**SAN ANTONIO WATER SYSTEM  
CROSS MOUNTAIN ELEVATED STORAGE TANK  
SAWS Job No. 07-6006-113  
Solicitation No. B-10-053-MR**

**ADDENDUM NO. 1**

**September 29, 2010**

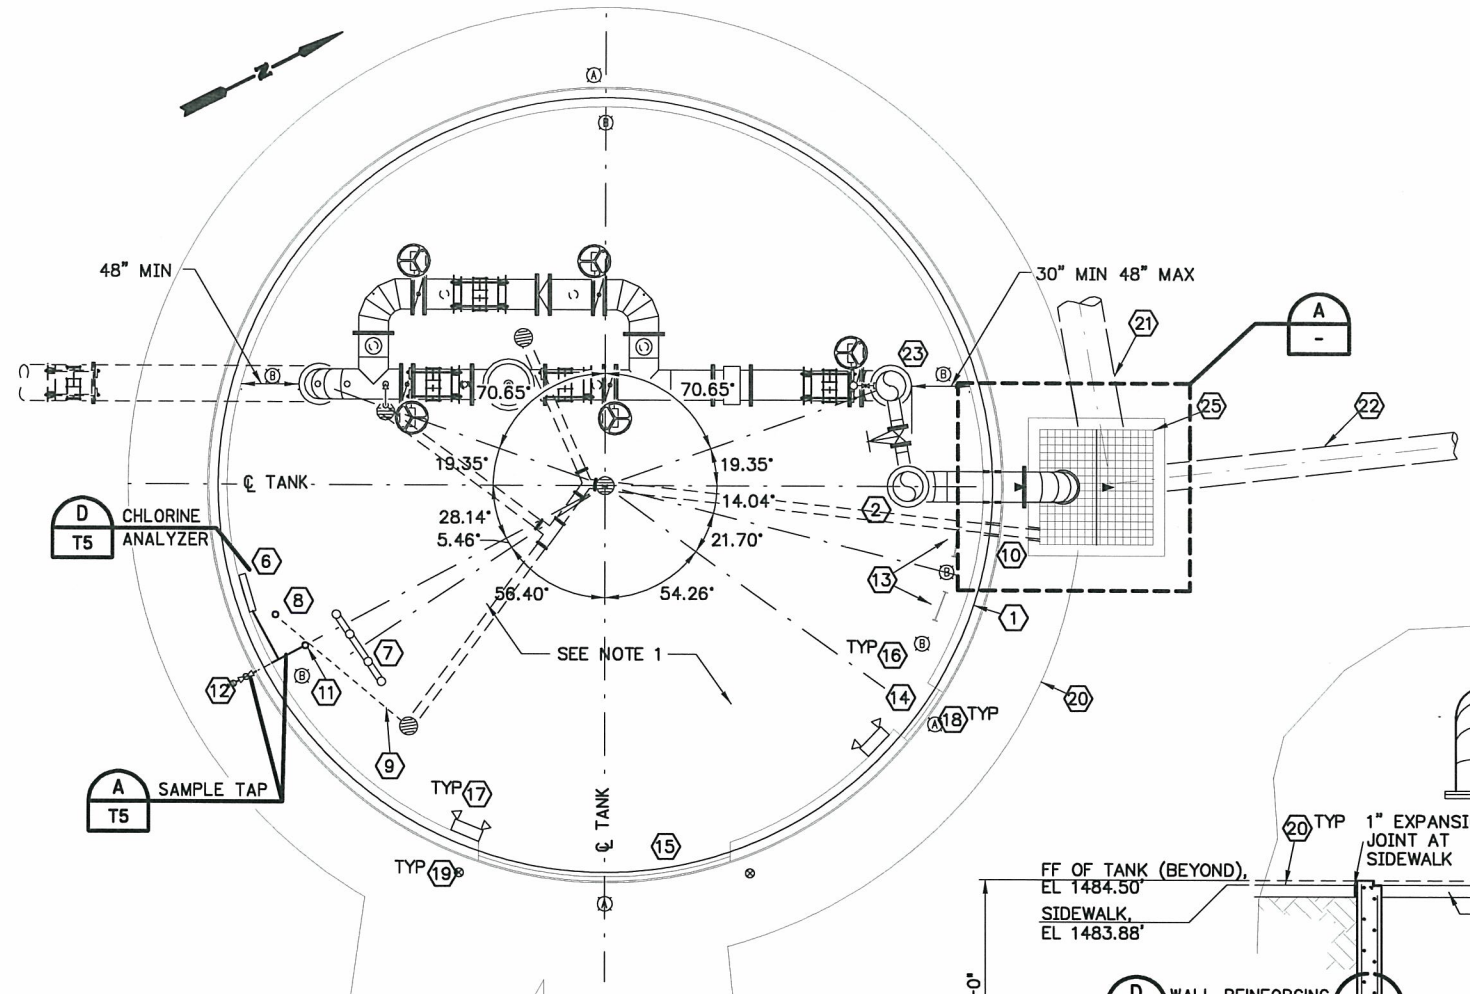
14. Question: Drawing T-1 specifies a 42 ft minimum insides pedestal diameter, however the 42 ft is dimensioned to the outside of the pedestal diameter, Regardless we suggest the drawing be revised to 42 ft +/- 2ft to allow individual manufacturers standard pedestal diameters.

16. Question: Drawing T-1 shows the access tube extending down to the upper platform complete with a 36x84 opening. This is another manufacturers standard. Our standard does not permit the access tube to extend past the tank floor. Both standards allow for continuous ladder access from the upper platform to the tank roof. Please confirm individual manufacturers standards will be acceptable with respect to the access tube.

17. Question: Drawing T-1, Note 19 specifies a stainless steel “protective rail” within the tank at the floor manhole and at the inlet/outlet piping openings. Can a detail or description be provided?

36. DRAWING NO. T-1

- a. Delete General Note 9 in its entirety and replace with “SECURITY ANTENNA (1), AND SCADA ANTENNA MASTS (2 TOTAL – 1 SPARE) TO BE DESIGNED AND SUPPLIED BY TANK MANUFACTURER.”
- b. Add the following note:  
”TANK BOWL:  
25. BOTTOM CONE SHALL BE DIRECTLY PROPORTIONAL TO THE SHELL IN ORDER TO CONFORM TO THE TANK BOWL SHAPE AS SHOWN IN THE ELEVATION ON THIS SHEET. TANK MANUFACTURER SHALL SUBMIT PROPOSED TANK BOWL SHAPE AND ALL DIMENSIONS TO OWNER FOR REVIEW AND APPROVAL PRIOR TO BEGINNING MANUFACTURE. OWNER SHALL HAVE THE RIGHT TO REQUEST MODIFICATIONS, AS REQUIRED TO ACHIEVE THE BOWL SHAPE AS SHOWN IN THE ELEVATION”
- c. Tank pedestal dimension was modified to accurately reflect relation to interior pedestal diameter.

*Response: Dimension will be revised, refer to Item 36 below. Refer to Note 8 on Sheet C-1 addressing allowance of other manufacturers standard pedestal diameters and the resulting modifications that will need to be provided for engineers review at no additional cost.*

Response: *Owners preference is that the access tube extend down to the upper platform for the safety of personnel working at the facility.*

Response: *Protective rail is to be provided at access openings within the tank per Note 19 on Sheet T-1. Rail design is to match those found on T-4 and T-5 of the plans.*

- BOTTOM CONE SHALL BE DIRECTLY PROPORTIONAL TO THE SHELL IN ORDER TO CONFORM TO THE TANK BOWL SHAPE AS SHOWN IN THE ELEVATION ON THIS SHEET. TANK MANUFACTURER SHALL SUBMIT PROPOSED TANK BOWL SHAPE AND ALL DIMENSIONS TO OWNER FOR REVIEW AND APPROVAL PRIOR TO BEGINNING MANUFACTURE. OWNER SHALL HAVE THE RIGHT TO REQUEST MODIFICATIONS, AS REQUIRED TO ACHIEVE THE BOWL SHAPE AS SHOWN IN THE ELEVATION.

ALTITUDE VALVE PIPING - PLAN  
 SCALE IN FEET

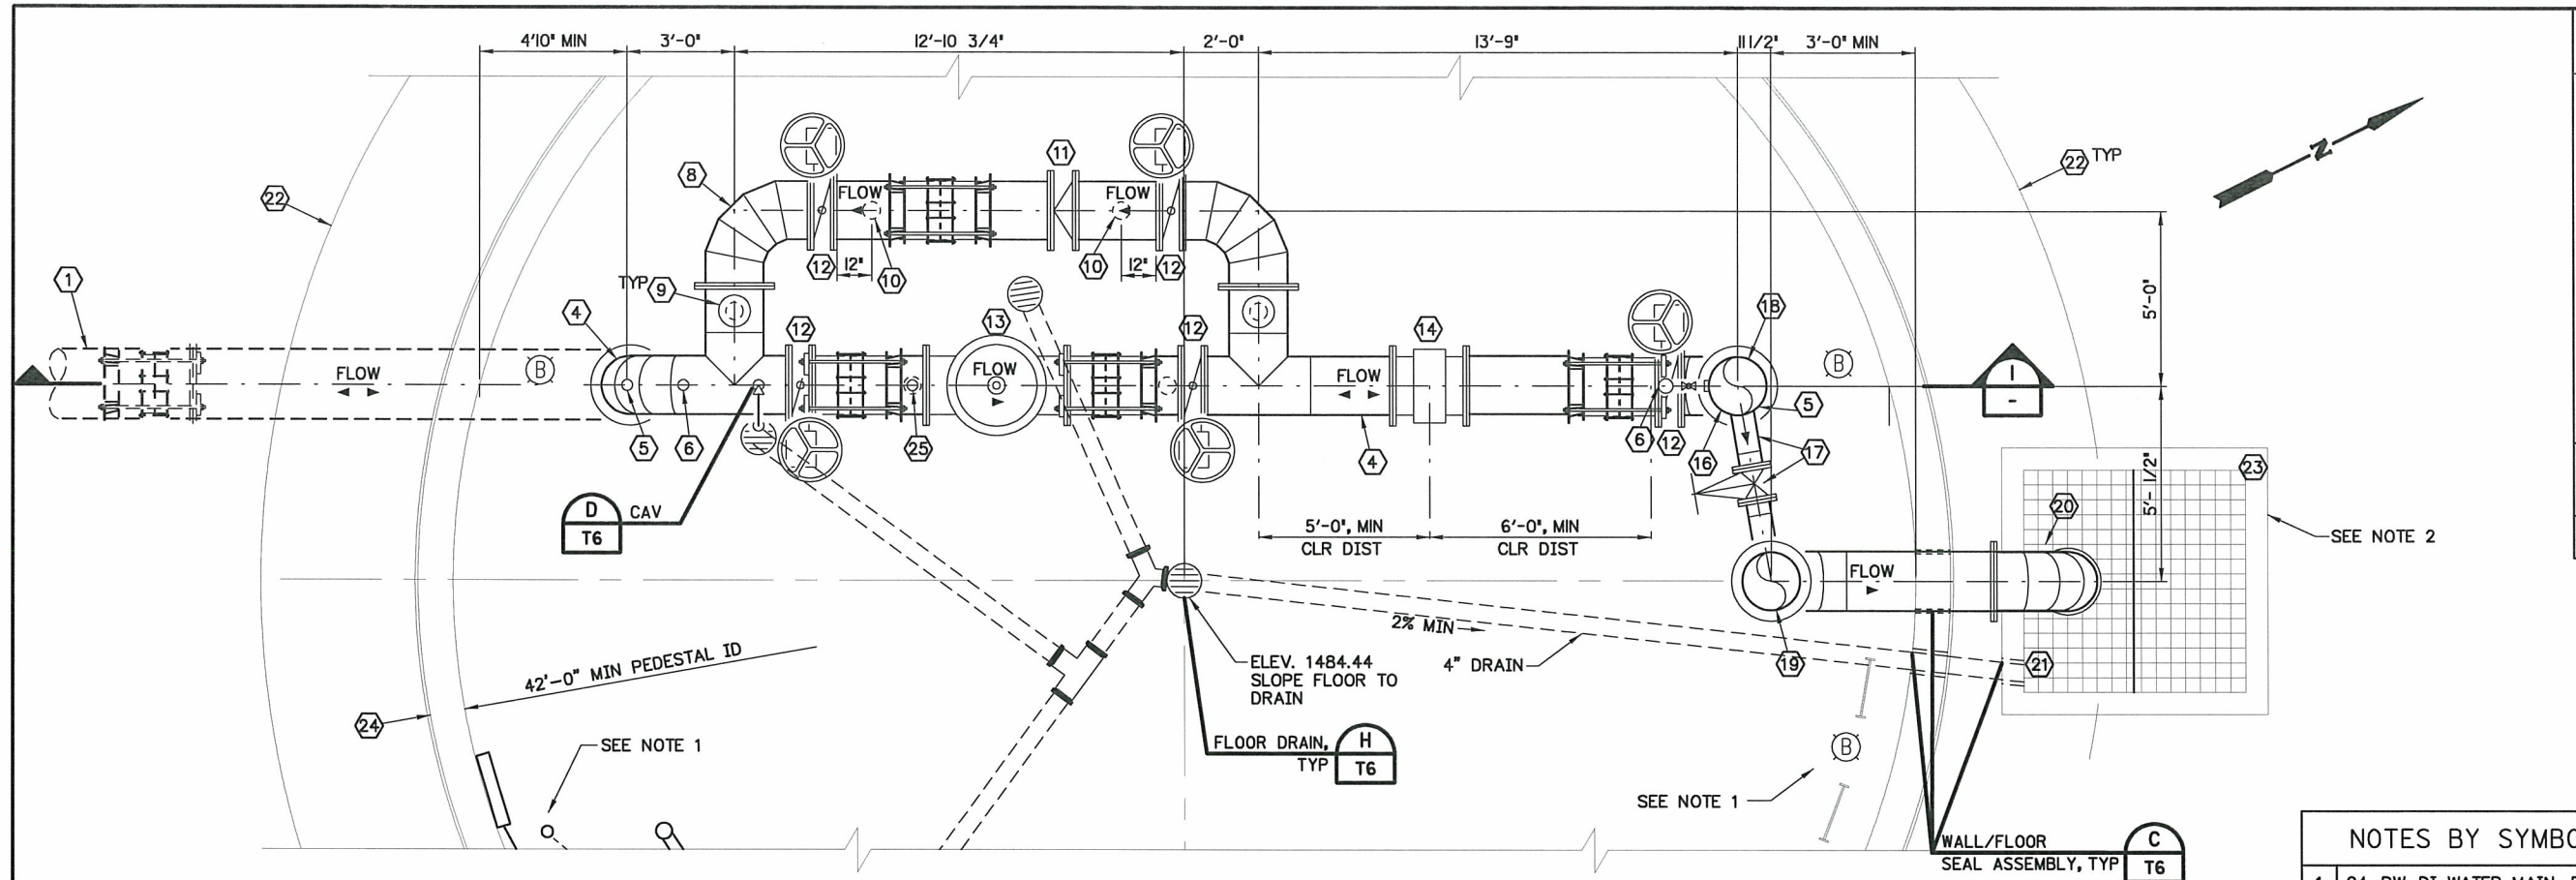
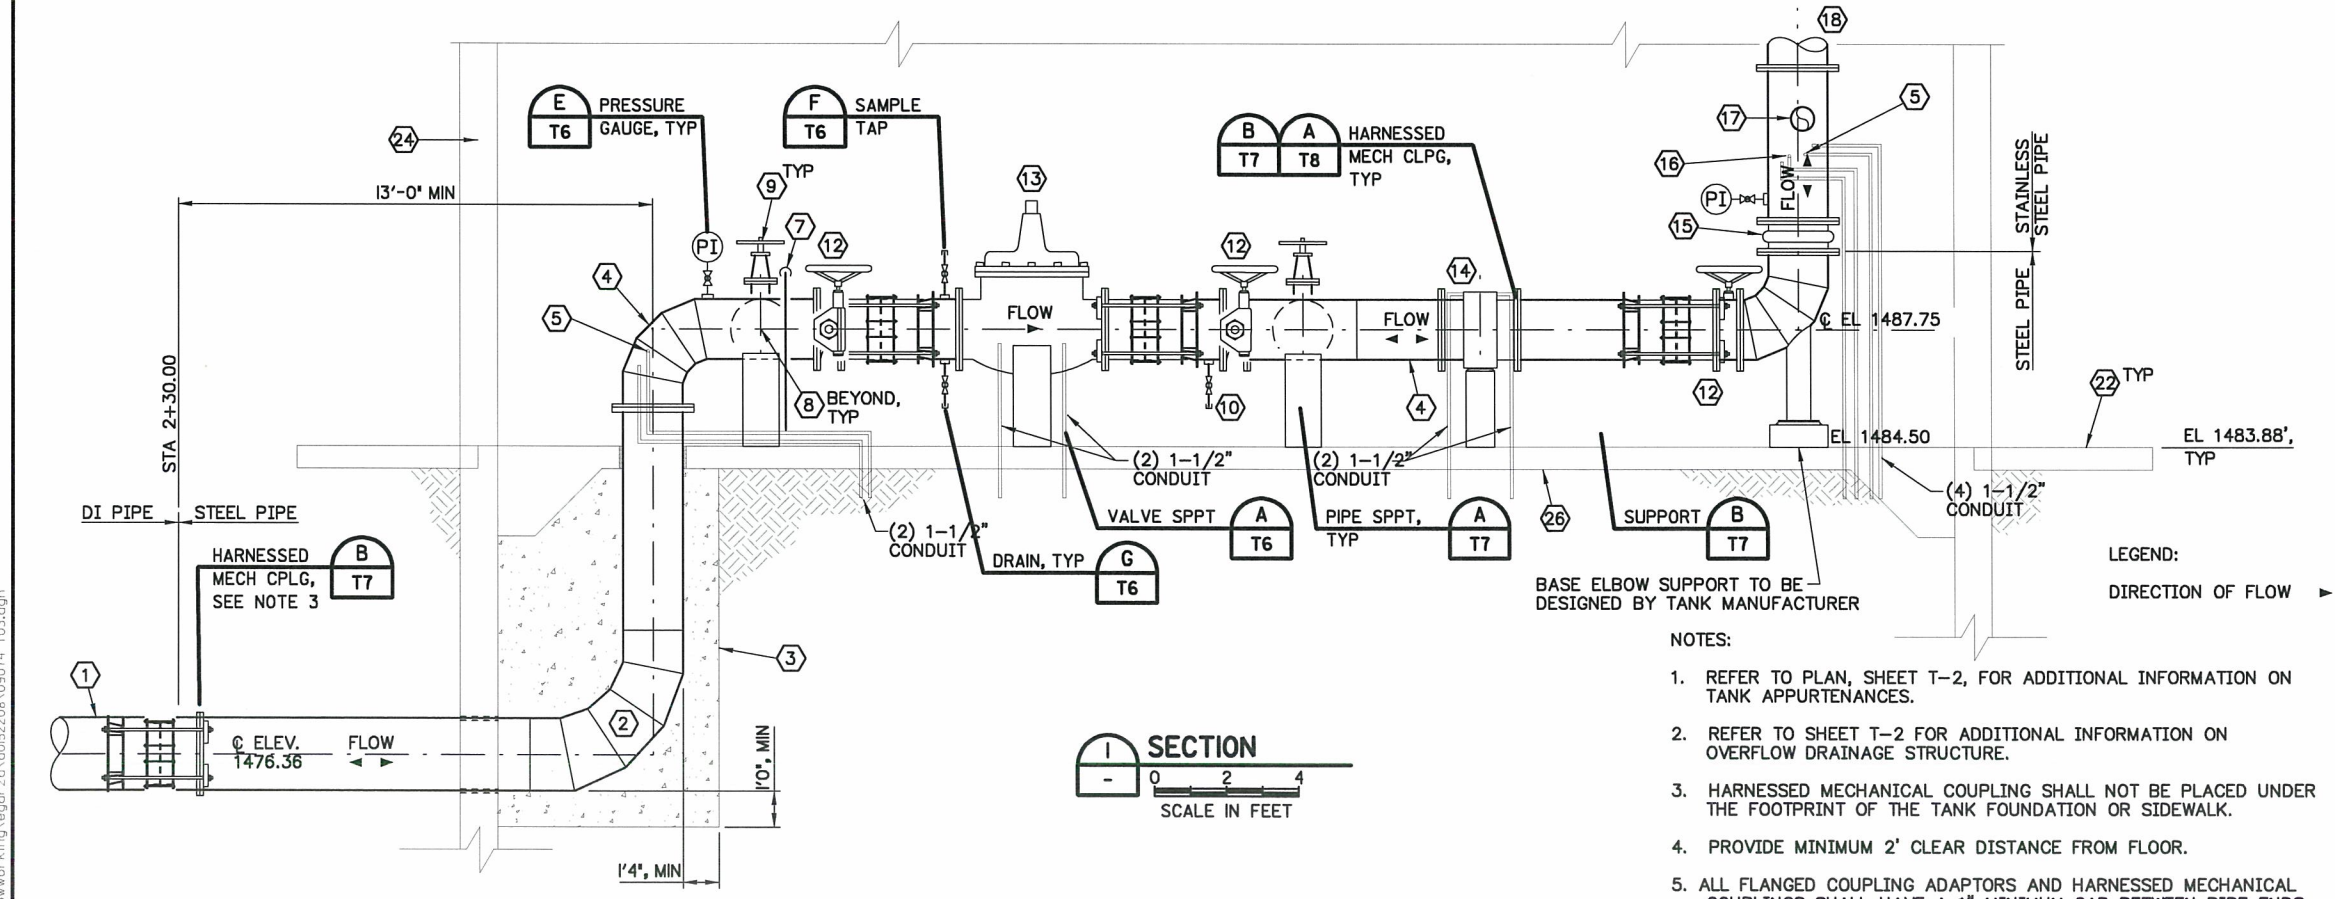
18. Question: Drawing T-2 shows a stainless steel expansion joint on the overflow. Typically this is not required as any differential movement would be accommodated by the horizontal section of piping below the tank bowl. Please advise.

19. Question: Drawing T-3. Please confirm the Steel Pipe is 0.375 wall pipe, fusion bonded epoxy coated both interior and exterior per Section 15060 or advise otherwise.

20. Question: Drawings T-3. Please confirm bolts and nuts for the flanged connections are 316 stainless steel or advise otherwise.

Response: *Stainless steel expansion joint is a SAWS requirement and must be provided.*

Response: *Confirmed, only NSF approved coatings will be accepted. Final exterior color to be selected by the Owner.*

Response: *Confirmed.*
